## *City of El Paso – City Plan Commission Staff Report*

**Case No:** SUSU11-00132 Tierra Del Este Unit Sixty Nine  
**Application Type:** Major Final  
**CPC Hearing Date:** February 9, 2012  
**Staff Planner:** Justin Bass, (915) 541-4930, [bassjd@elpasotexas.gov](mailto:bassjd@elpasotexas.gov)  
**Location:** South of Ralph Seitsinger Drive and East of John Hayes Street  
**Acreage:** 90.16 acres  
**Rep District:** 5  
**Existing Use:** Vacant  
**Existing Zoning:** R-5 (Residential)  
**Proposed Zoning:** R-5 (Residential)  
**Nearest Park:** Tim Foster Park (0.30 mile)  
**Nearest School:** El Dorado 9<sup>th</sup> Grade School (0.32 mile)  
**Park Fees Required:** N/A  
**Impact Fee Area:** A portion of this property is located in the Eastside Impact Fee Service Area and is subject to impact fees.  
**Property Owner:** Ranchos Real XIV, LLC  
**Applicant:** Conde, Inc.  
**Representative:** Conde, Inc.

## ATTACHMENT 3

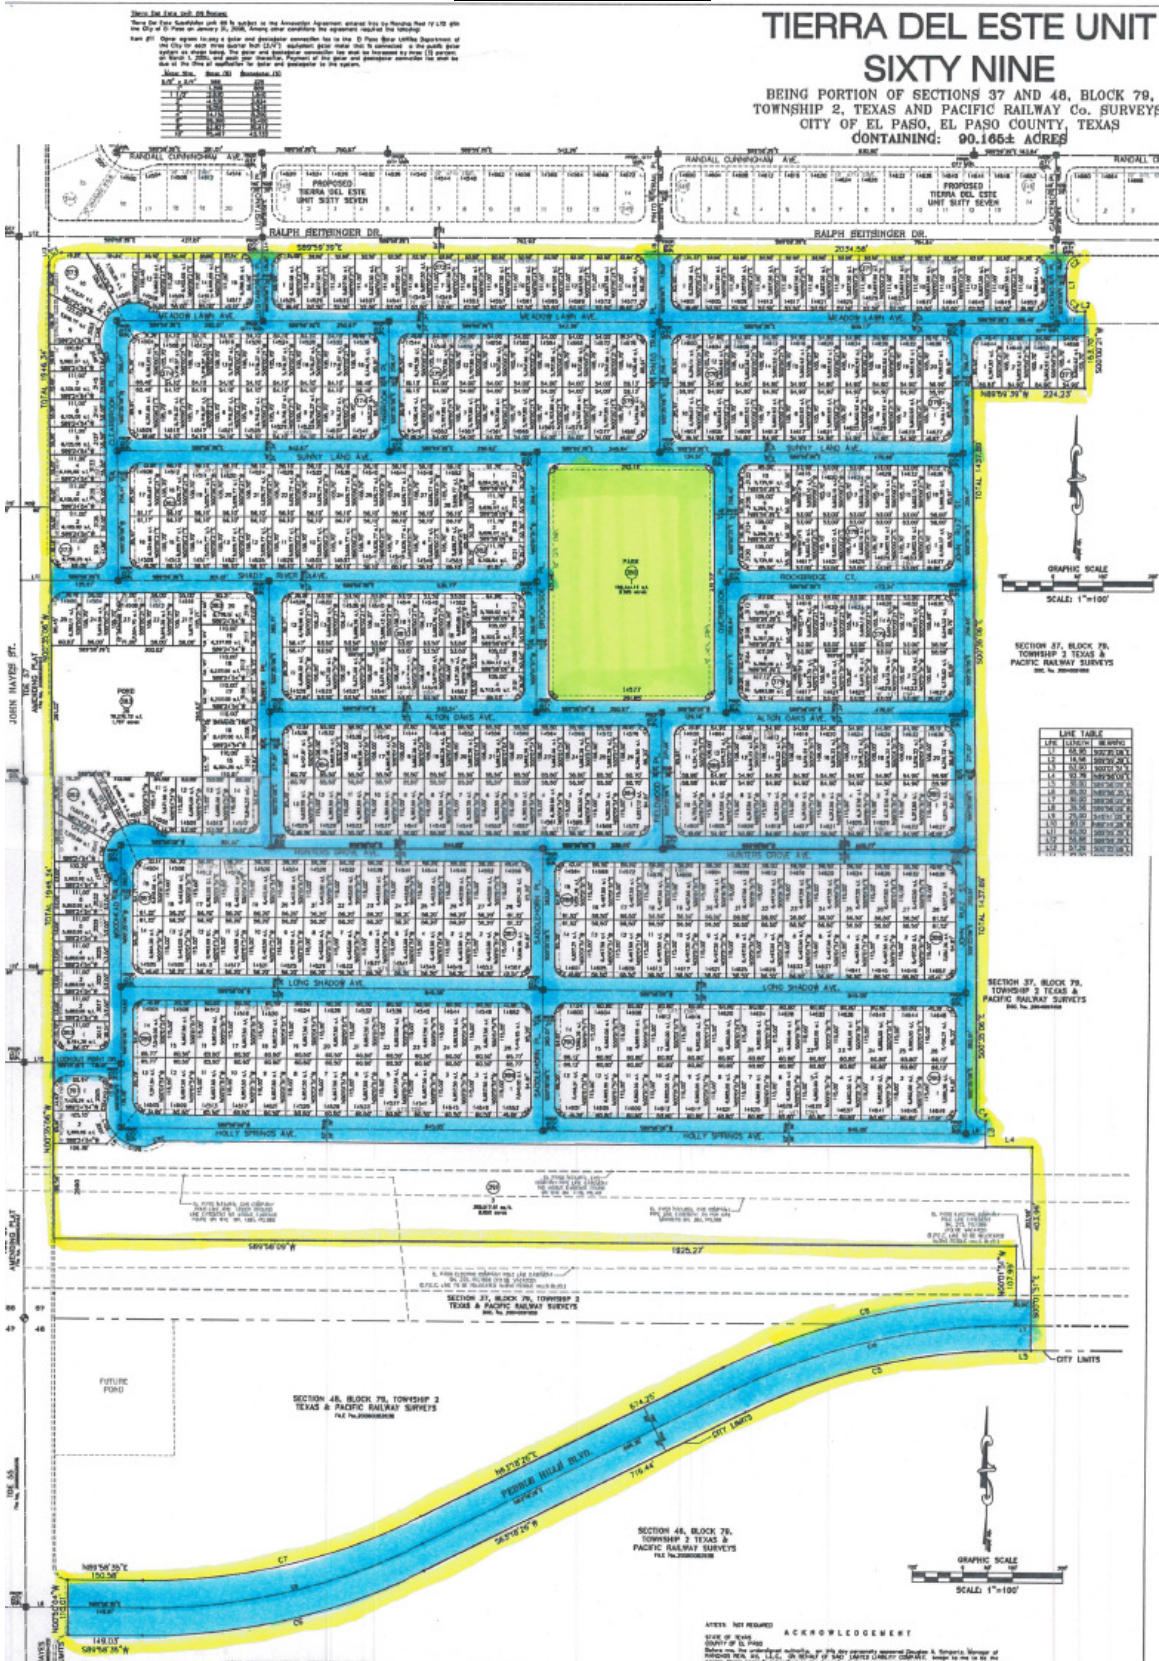
1. Provide Date of Preparation.
2. Provide print-out of the mathematical closure of the exterior boundary of the subdivision indicating the error of closure.

1. Tierra Del Este Unit 57 Amending Plat and Tierra Del Este Unit 67 shall be recorded prior to the subdivision to ensure adequate access to John Hayes.
2. The median opening at the end of Pebble Hills shall be at least 45ft. to ensure an adequate turning radius for fire and sanitation trucks at the end of Pebble Hills.
3. The Developer shall contribute their proportionate share of traffic mitigation improvements for the following intersections:
  - a. Rich Beem and Ralph Seitsinger (\$15,395.01)
  - b. Pebble Hills and Rich Beem (\$14,333.29)
  - c. Pebble Hills and Tim Foster (\$21,765.36)
  - d. Pebble Hills and John Hayes (\$32,913.48)
  - e. Edgemere and Tim Foster (\$20,172.78)
  - f. Edgemere and John Hayes (\$31,851.75)
  - g. Ralph Seitsinger and John Hayes (\$35,567.79)

Double frontage lots along John Hayes and Ralph Seitsinger shall comply with Section 19.23.040 H (Double Frontage Lots) of the El Paso City Code.

Landscape, vegetation and irrigation systems are to be provided within the proposed median on Pebble Hills.

1. Temporary end-of-road markers or Type III Barricades shall be placed at the ends Meadow Lawn and Lookout Point.
2. All proposed/existing paths of travel (accessible sidewalks, wheelchair access curb ramps and driveways) located within public rights-of-way shall be constructed in compliance with the

1. Stormwater drainage facilities that are to be maintained by EPWU shall be encompassed within a designated City-owned property or right-of-way. Public storm sewers shall be accessible for inspection and maintenance by the City. Change the drainage easements (for storm drain pipe) located within residential lots to drainage right-of-ways (Lot 16, Block 383 and Lot 23, Block 383).

3. Design of the ponding area shall meet all subdivision ordinance requirements for a retention basin. Provide results of retention basin boring and percolation tests performed according to City of El Paso Design Standards. Ensure that results show existing subsurface soil profiles, soil types and conditions. EPWU recommends boring 10' (feet) below the proposed bottom surface of the basin. Note the plasticity index, elevation of water table if applicable, percolation rate and whether the soil is cohesive or non-cohesive.

4. At the improvement plan stage protect the subject property from stormwater runoff from the undeveloped terrain.
5. At the improvement plan stage mitigate the amount of stormwater runoff on streets by extending an underground storm sewer system to capture street flow at critical points.

6. Incorporate principles of low impact development (such as recessed landscaping, rainwater harvesting, and porous pavements) to reduce the amount of developed stormwater runoff. Consider depressing the area between the house and right-of-way line to retain additional stormwater runoff. Provide additional stormwater retention at the park sites and landscaped areas.

*(comment has been addressed)*
